ADDENDUM NO. 1

RAC PARKING LOT EXPANSION

LACEY CONTRACT NO. PW 2022-19

Issued this 25th day of September, 2023.

1 **ELECTRICAL SITE PLAN**
SCALE: 1" = 50'-0"

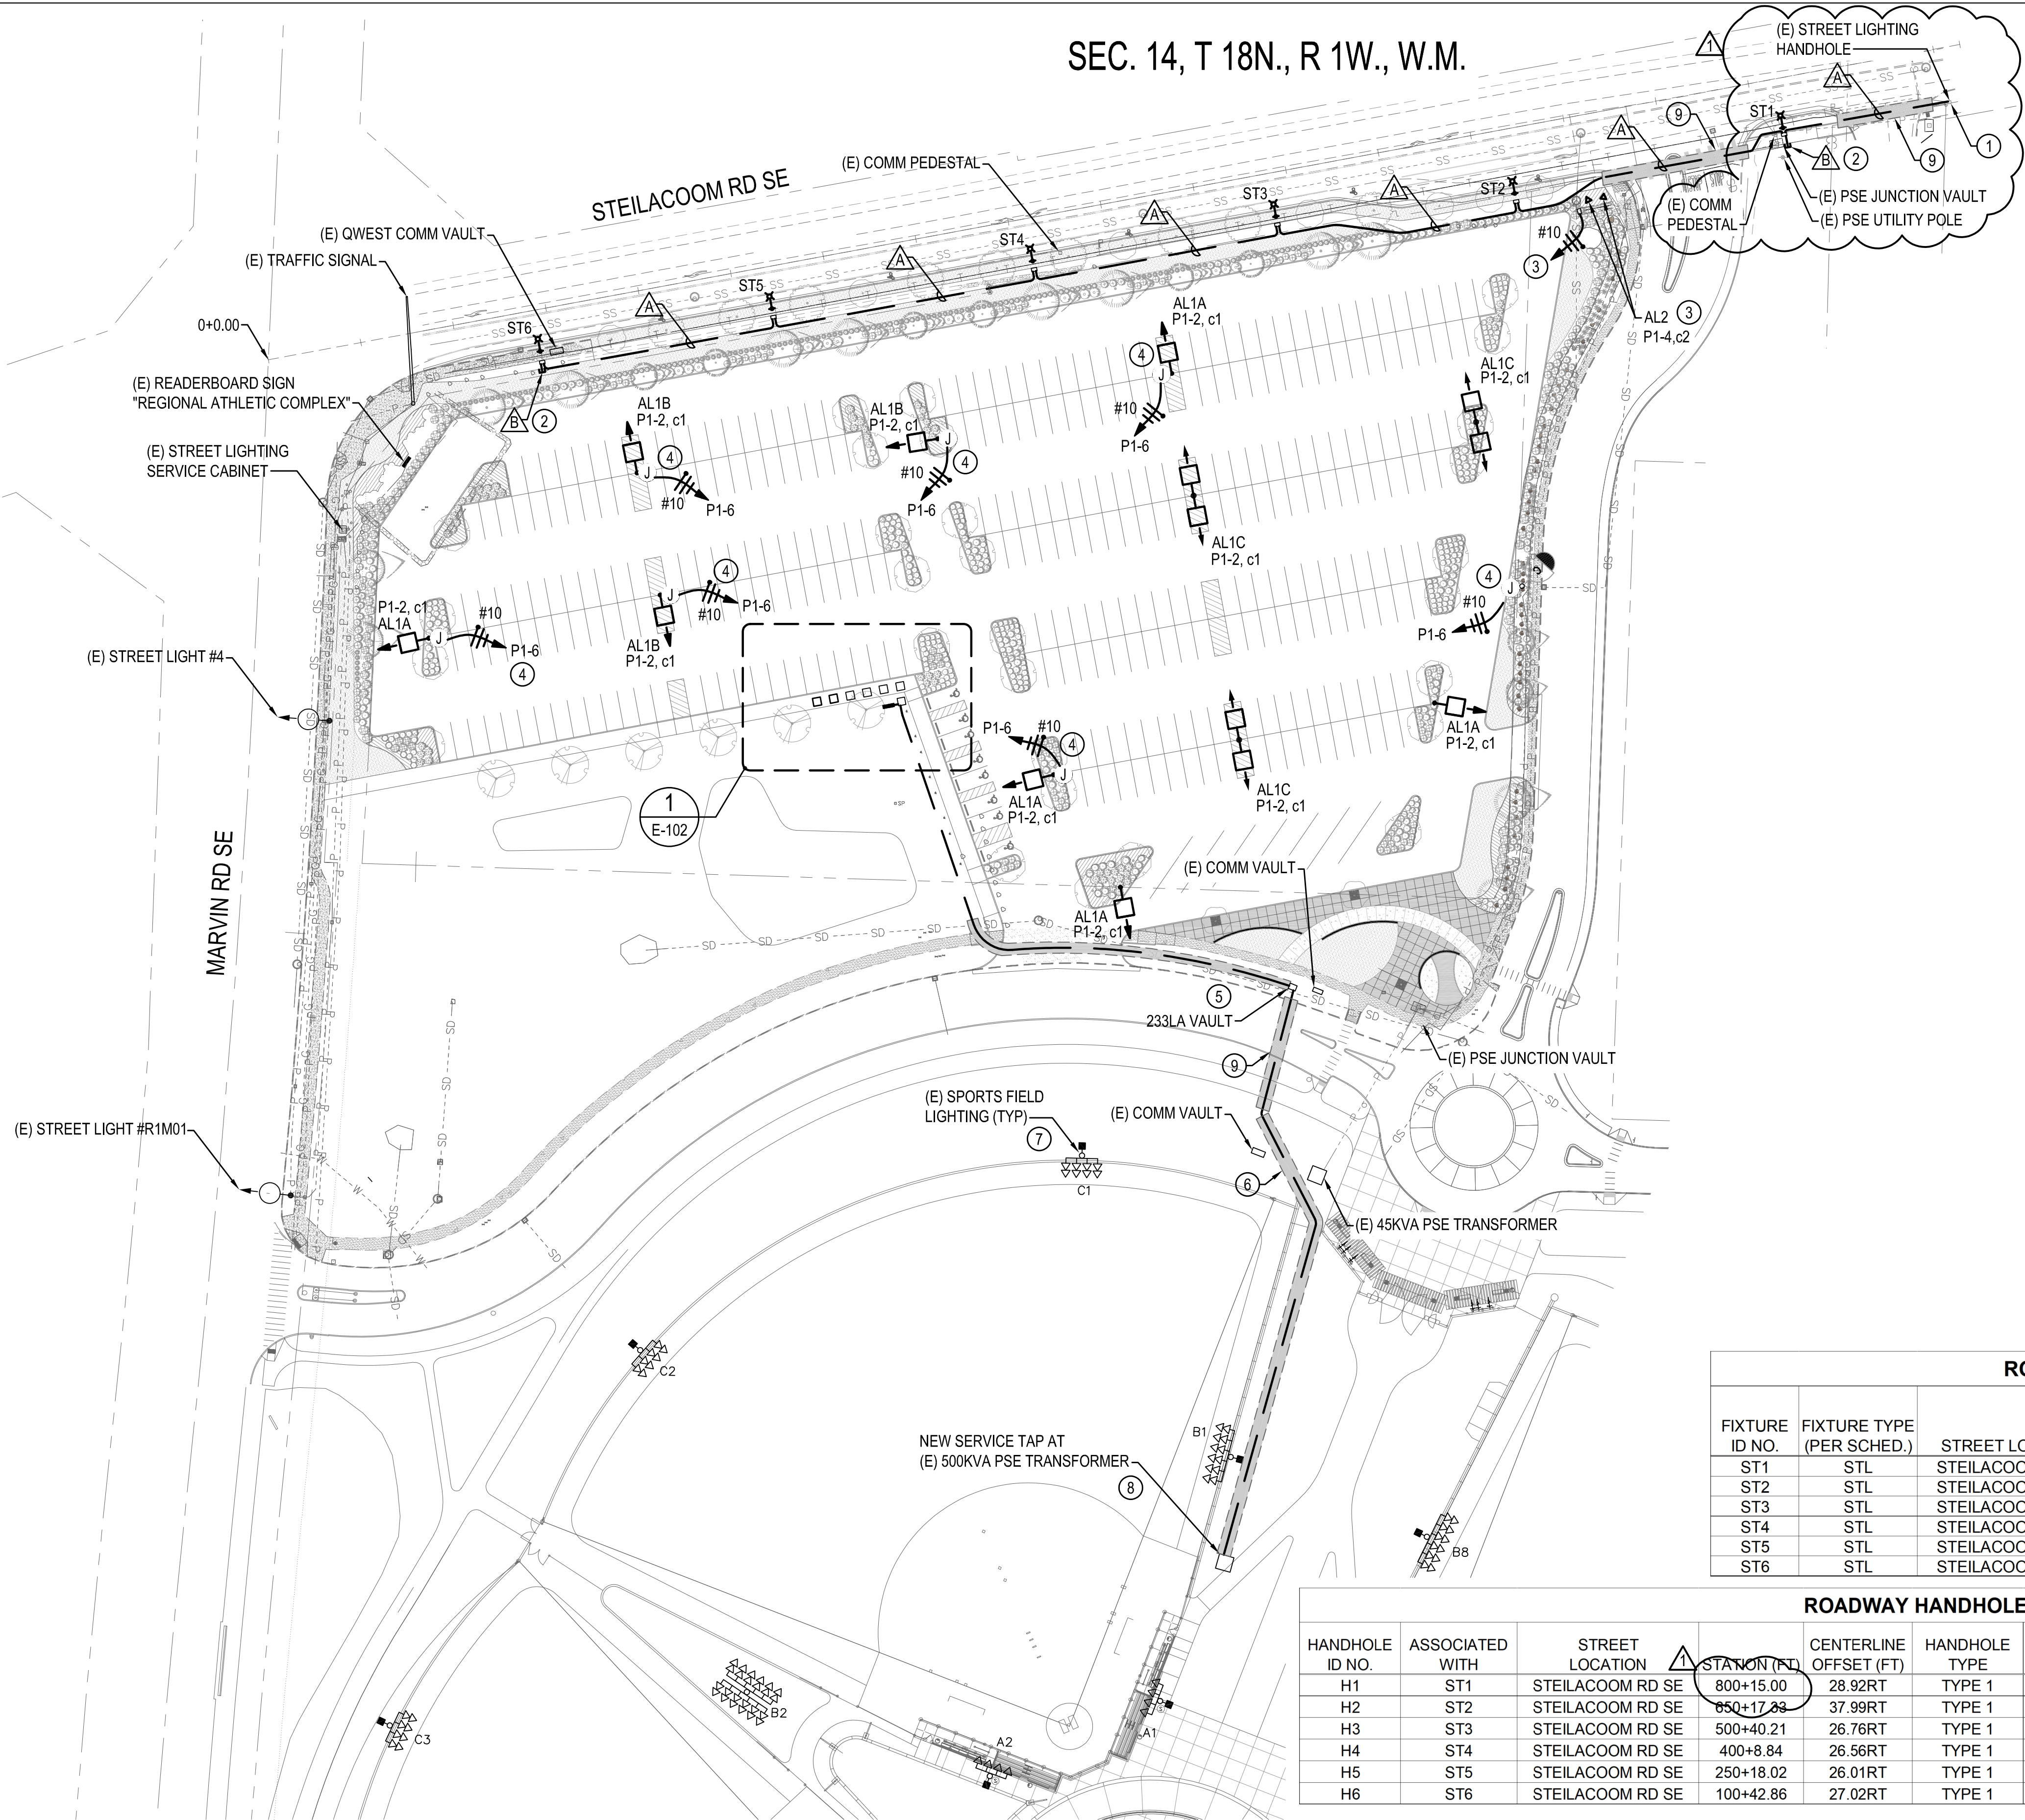
- 5) *The revisions include modifications to the schematics and callouts on Sheet E-101.*

Delete Sheet E-101 and replace it with the new page as attached.
